SUBMISSION TO AMENDMENT C295case TO THE CASEY PLANNING SCHEME CASEY FIELDS SOUTH & DEVON MEADOWS PRECINCT STRUCTURE PLAN

proUrban is pleased to provide this submission to the Victorian Planning Authority (VPA) in relation to exhibited Amendment C295case ('the amendment') to the Casey Planning Scheme – Casey Fields South and Devon Meadows Precinct Structure Plan (PSP).

MEMO

Figure 9: Casey Fields (Employment) PSP – Local Access Street – Employment Service Loop Cross-Section (20m)

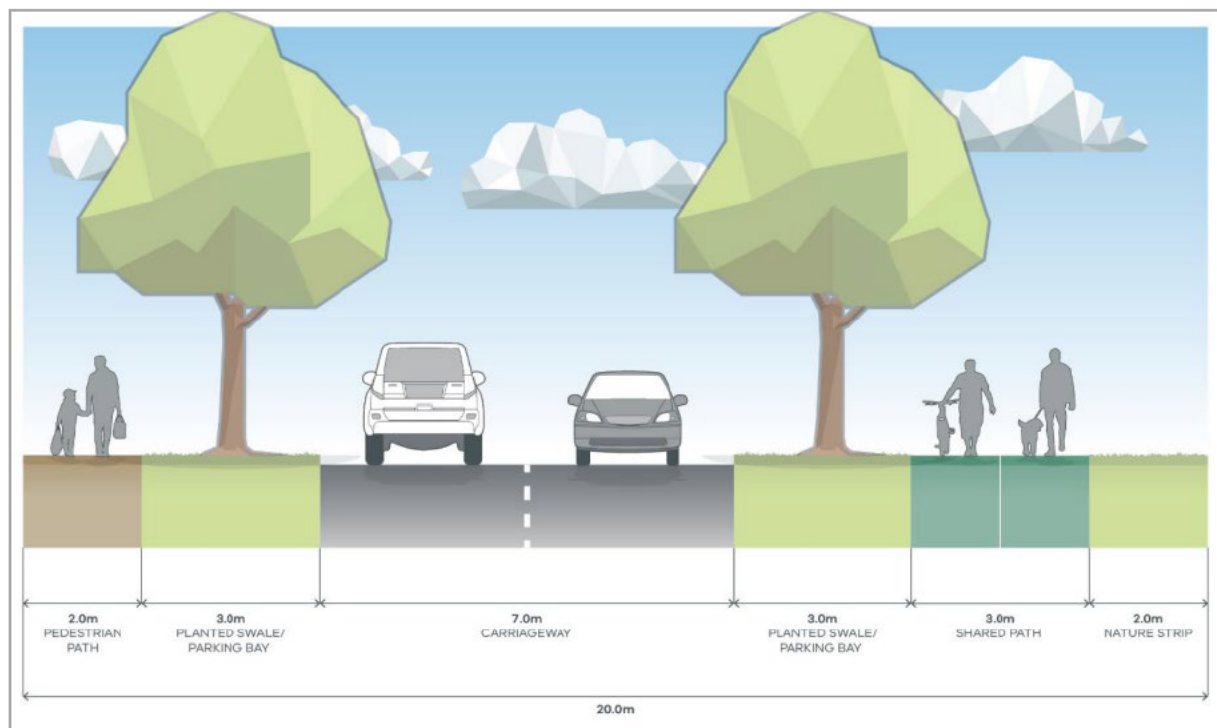
- The "key features" notation refers to ... *"generous planted nature strips on each side of carriageway to provide passive stormwater treatment, parking, lighting and seating"*. The nature strips are only 3m wide and are also proposed to accommodate a planted swale in addition to indented car parking and canopy trees. Indented truck parking bays need to be long enough for articulated trucks, leaving little room for planting. In an industrial/employment estate there would typically be a reasonable provision for on-street

parking (including for truck layover). Additionally, truck parking bays need to be a minimum of 2.6m wide, leaving only 0.4m for the planted swale.

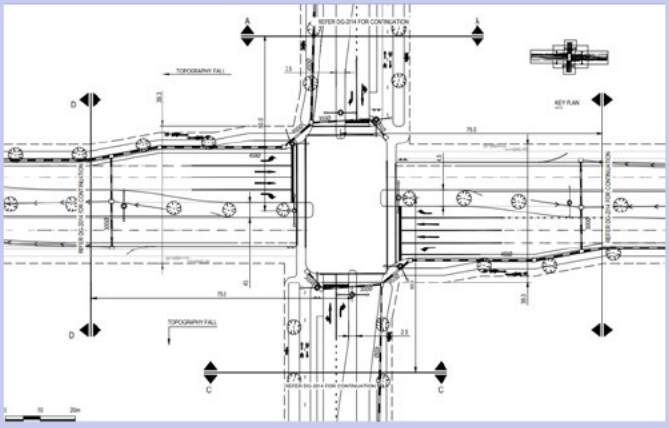
PSP Plan 11 indicates that intersections IN-05 and IN-06 are located predominantly within one title but have a small section which potentially extends across an adjacent lot in different ownership. This will make delivery of the intersections more difficult and should be avoided if possible.

Additionally, IN-05 does not appear to include any splays. It is noted that there is an existing wide verge on South Gippsland Highway and it is likely that the splays can be accommodated within the existing road reservation. However, this should be confirmed within the PSP with the inclusion of an intersection plan as DTP sometimes requires the verge width to be maintained at intersections which requires splays to accommodate turn lanes and impacts on developable area.
